Tropical Knitex Ltd.

Chandra, Kaliakoir, Gazipur-1751, Bangladesh

24th September 2019 , 6th October 2019 & 15th October 2019

Observations

Building 3

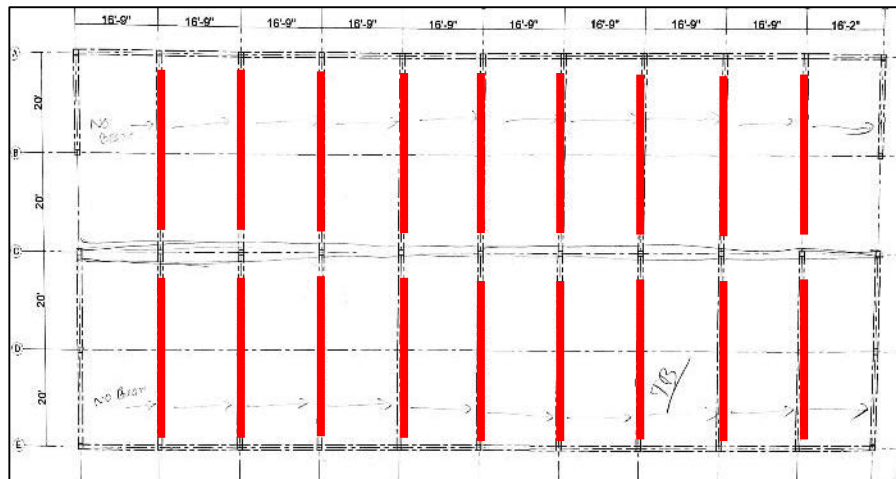
No connection details between steel roof truss and RC frame was available. The connections need check against the uplift forces to ensure structural stability.

Building 4

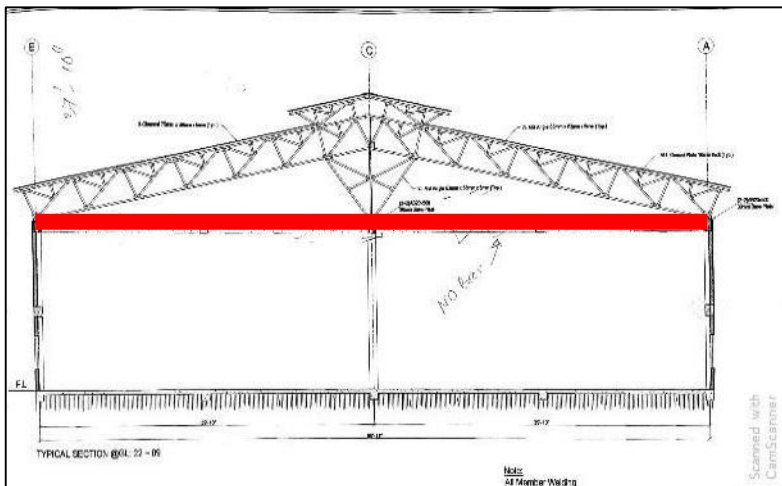
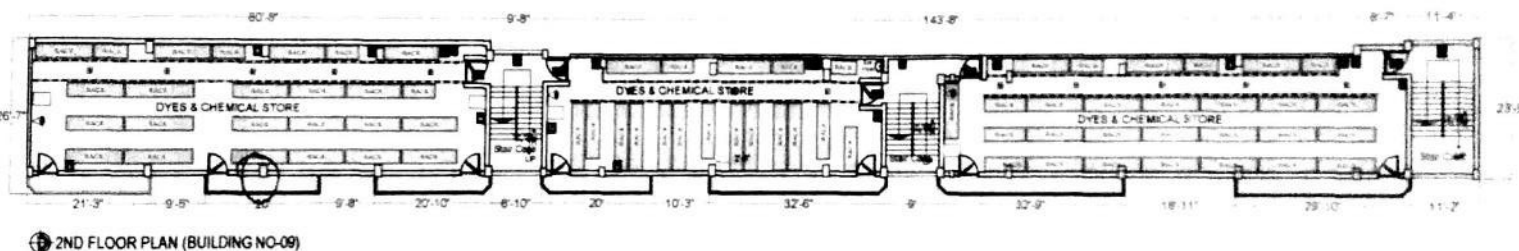
Missing beams are marked in Beam Layout plan.

Missing beam marked in Section

Missing tie beams in short direction. No horizontal bracing was found. And connection details unknown. Check for lateral stability and uplift is required to ensure building safety.

Floor plan

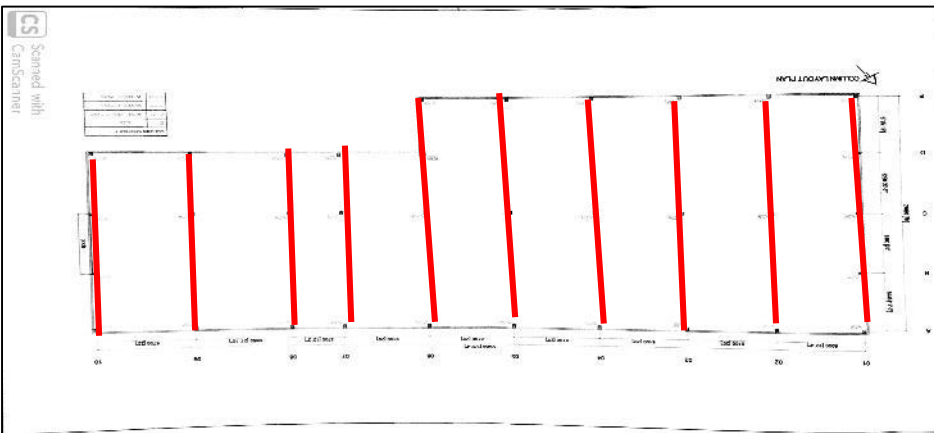
Apparently Building 9 is a slender building. Only one bay in weak direction. Lateral stability check is required.

Rafters marked in Plan

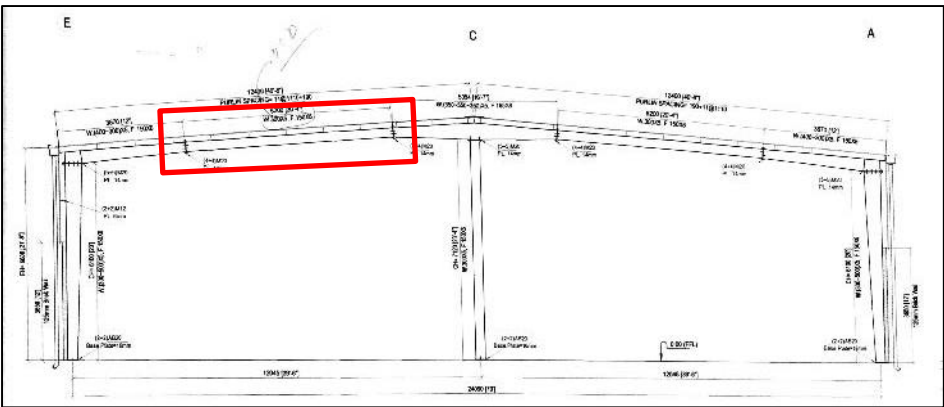
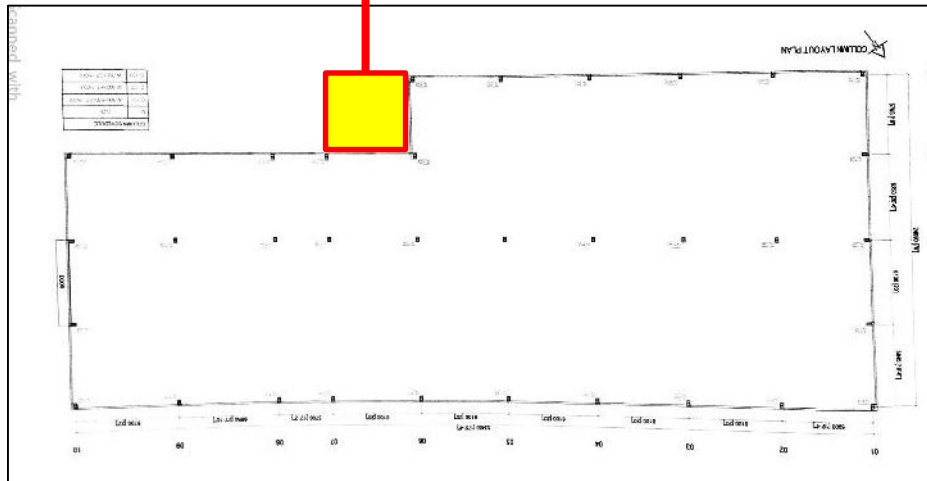
As per drawings, the marked rafters should have a width of 300 mm but on site the rafters width was found 250 mm.

Inside undocumented portion

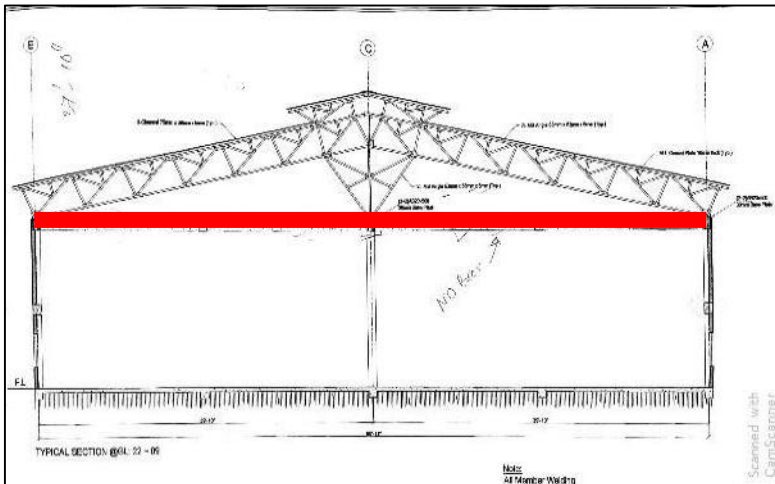
An extra undocumented portion was found which is not shown in the as built drawings.

Missing beam marked in Section

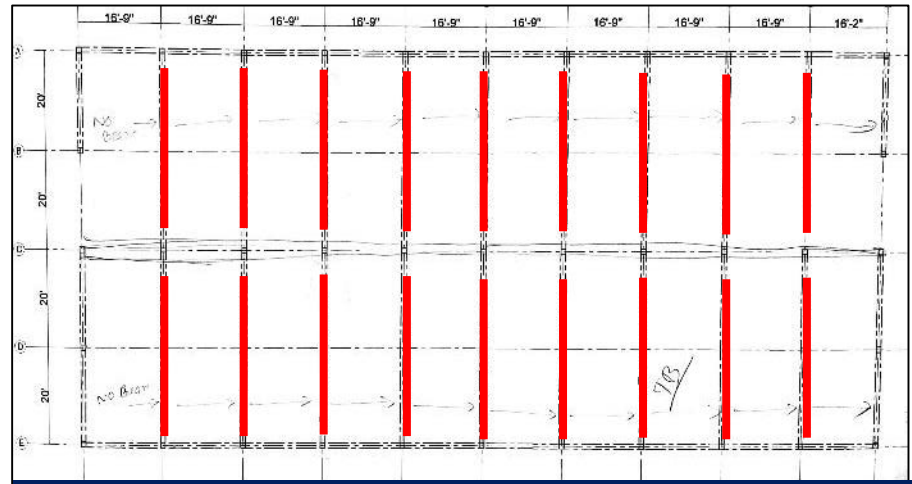
Missing beams are marked in Beam Layout plan.

As per beam layout the beams in the lateral direction were not observed during inspection.

Partial Column Layout

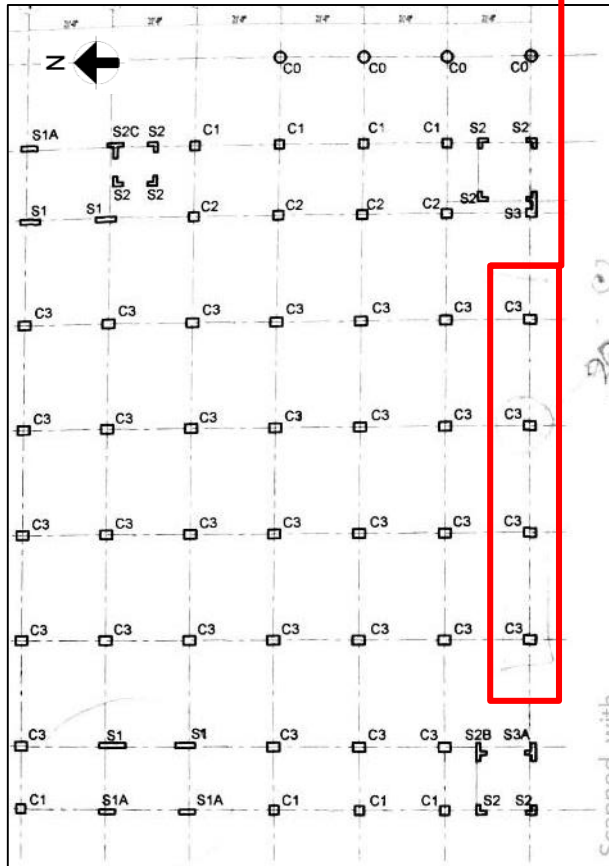
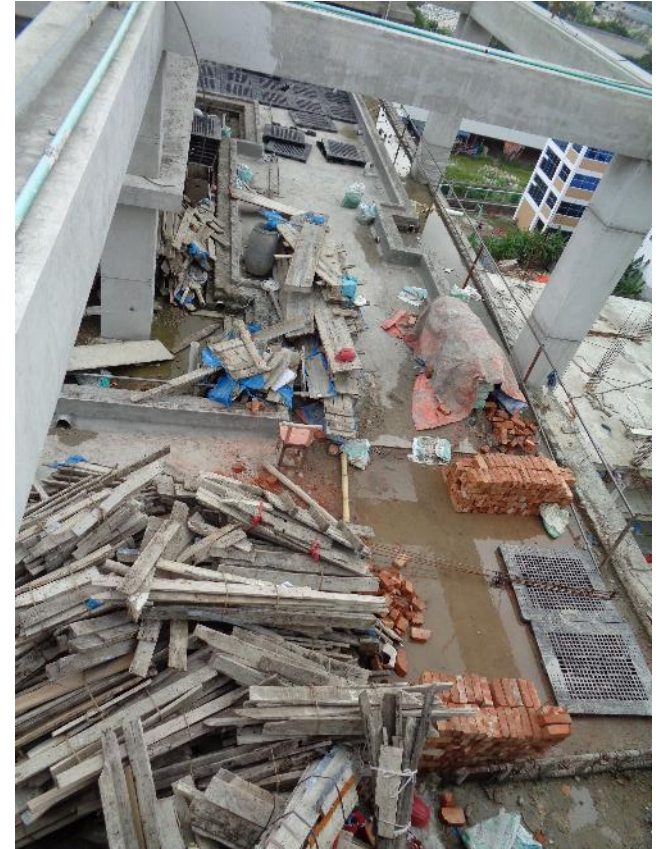
C3 column size in column schedule is mentioned to be 36" x 27"

During inspection, the marked columns in the column layout were found smaller than the indicated size in as built drawings. C3 column size in column schedule is mentioned to be 36"x 27". But during inspection, the column was measured 32" x 27".

Exposed corroded rebars in the roof

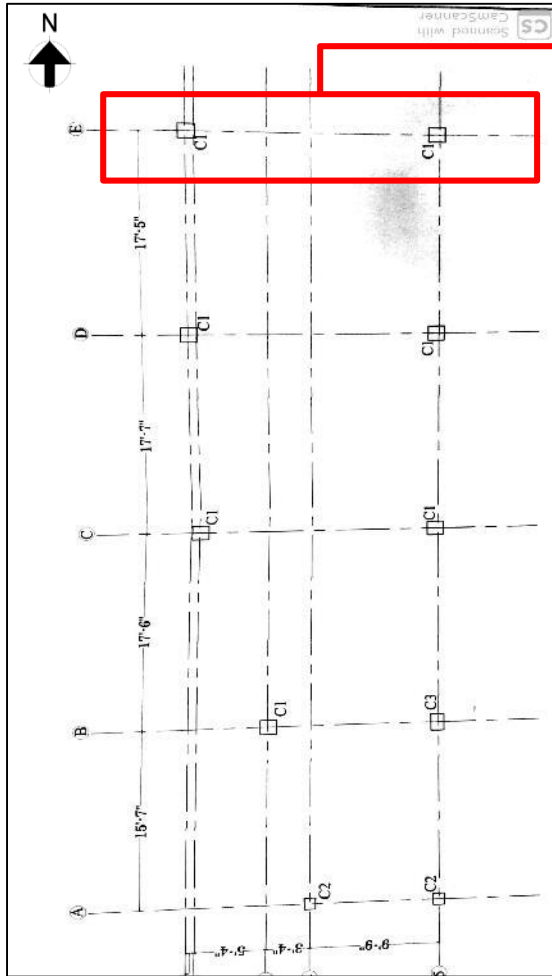
Exposed corroded rebars were found on the rooftop.

Beam Layout

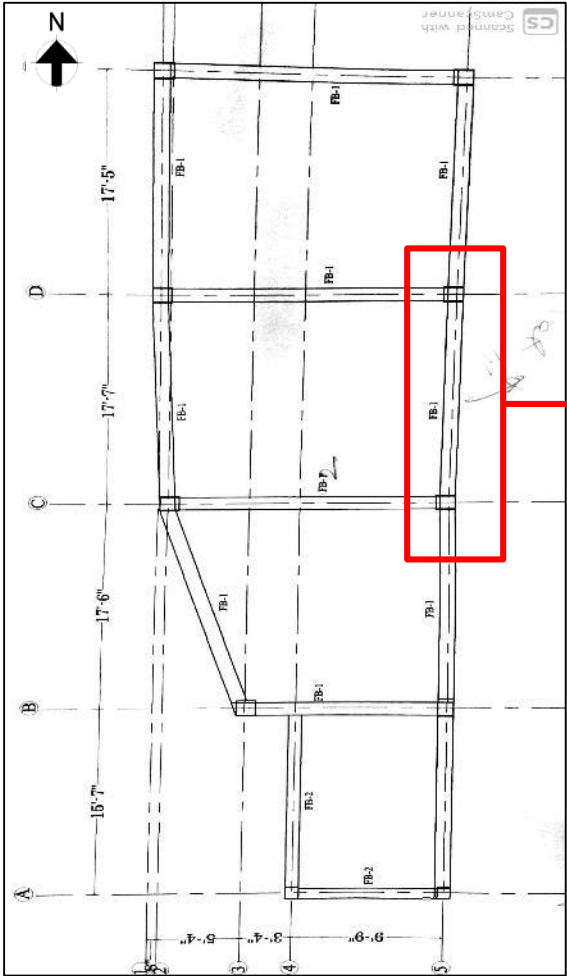
During inspection, the marked beam in the beam layout was found missing at 11' level.

Retrofitted columns

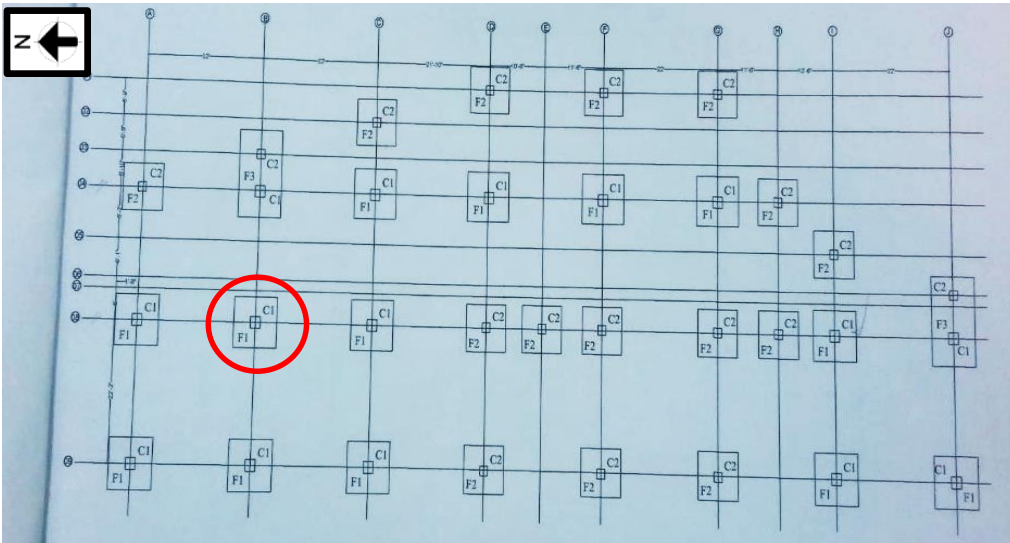
Discontinuous strap footing above ground.

Factory has completed retrofitting works in Building 9 and constructed a strap footing around the building. But no analysis report of these retrofitting works were available. Moreover, the load paths to ground aren't clear.

Red marked footing found over stressed

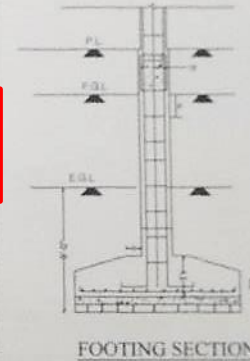
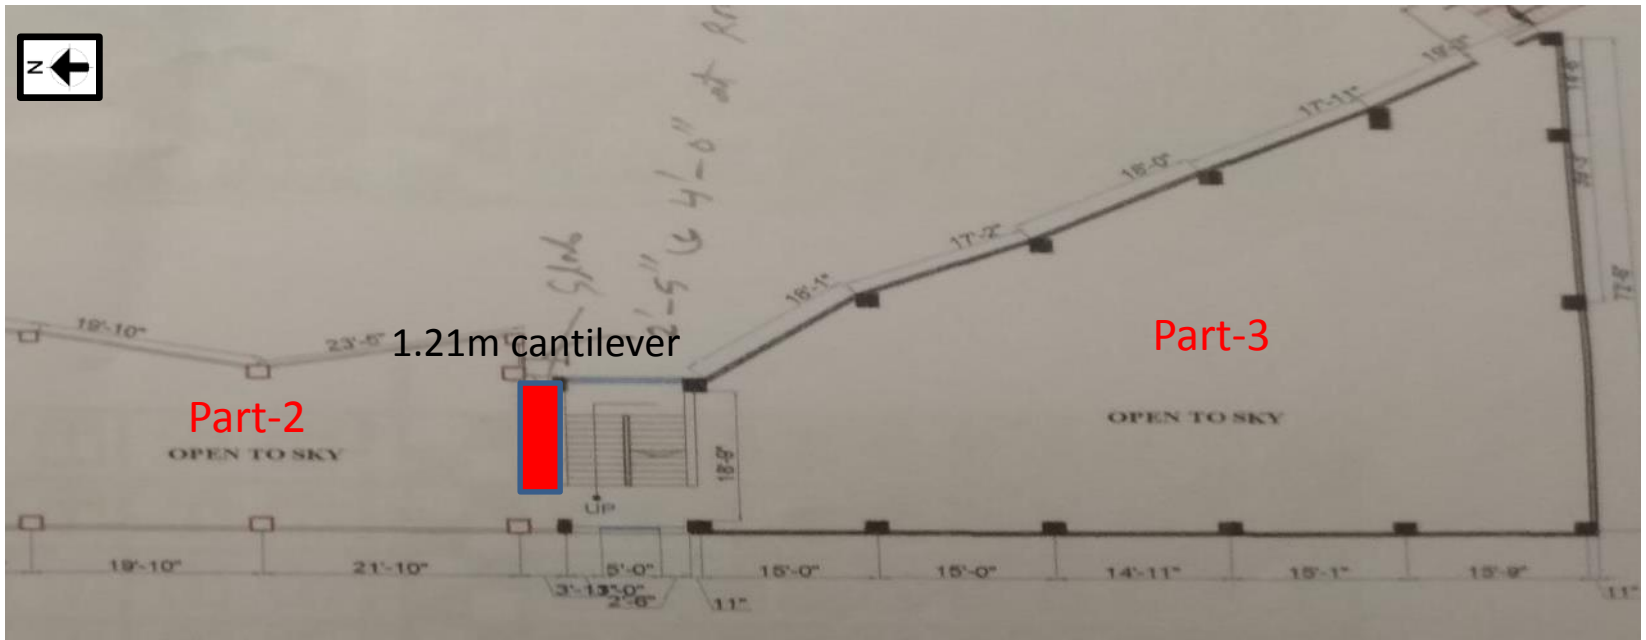
Cursory calculation indicates that the soil below isolated footing appears to be stressed above normal design limit considering the recommended soil bearing capacity in geotechnical investigation report and footing sizes mentioned in the provided drawing. Factory engineer is required to review the adequacy of footings and comply with BNBC.

1.21m cantilever at stair top

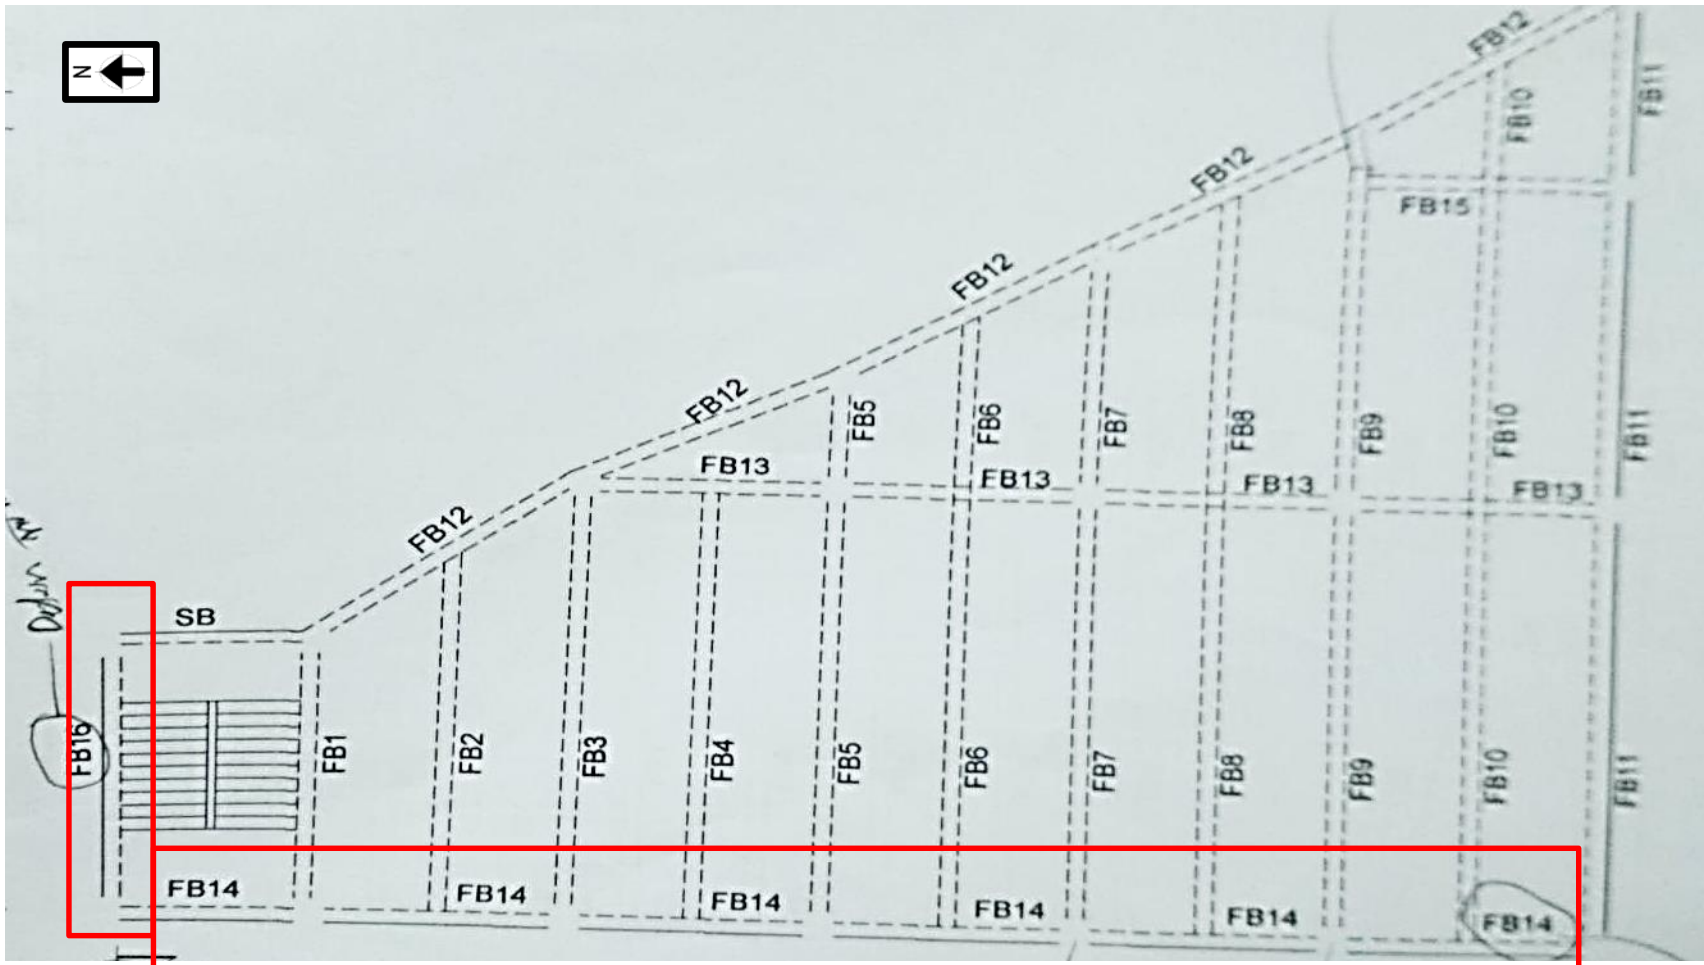
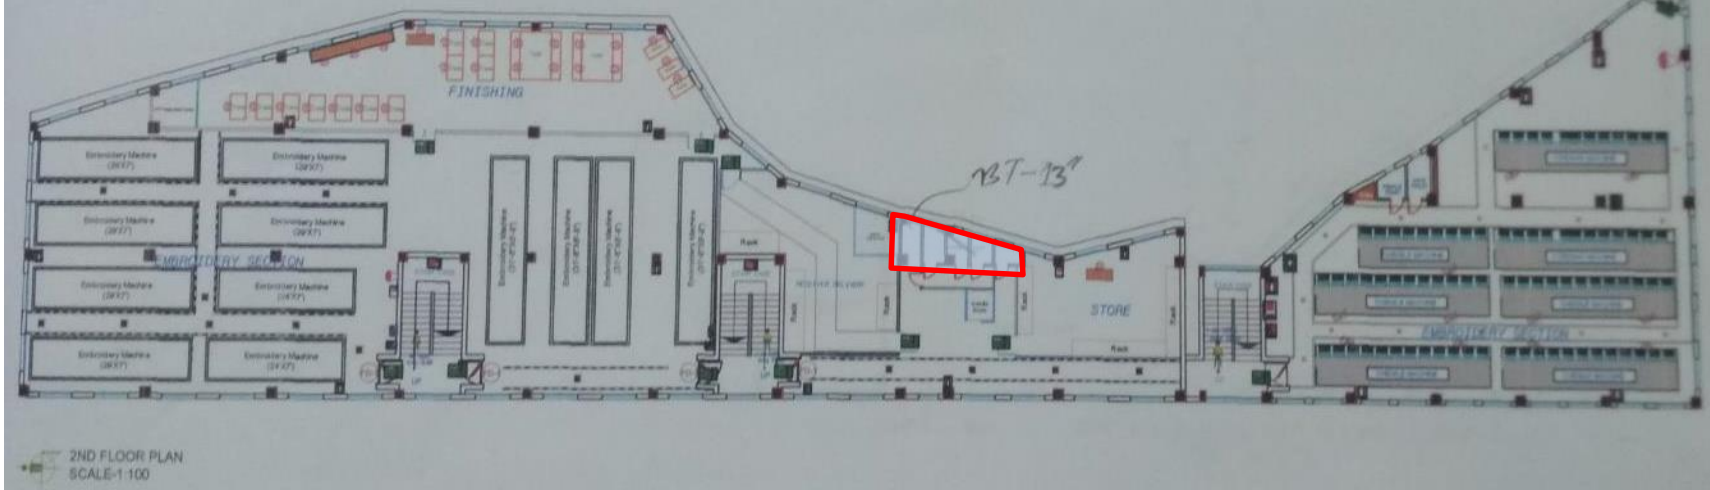
The cantilever slab of Part-3 was not mentioned in the as-built drawing.

Structural Details of FB14 & FB15 was not found in as built drawing. Factory engineer is required to update the as built drawing as per actual site condition.
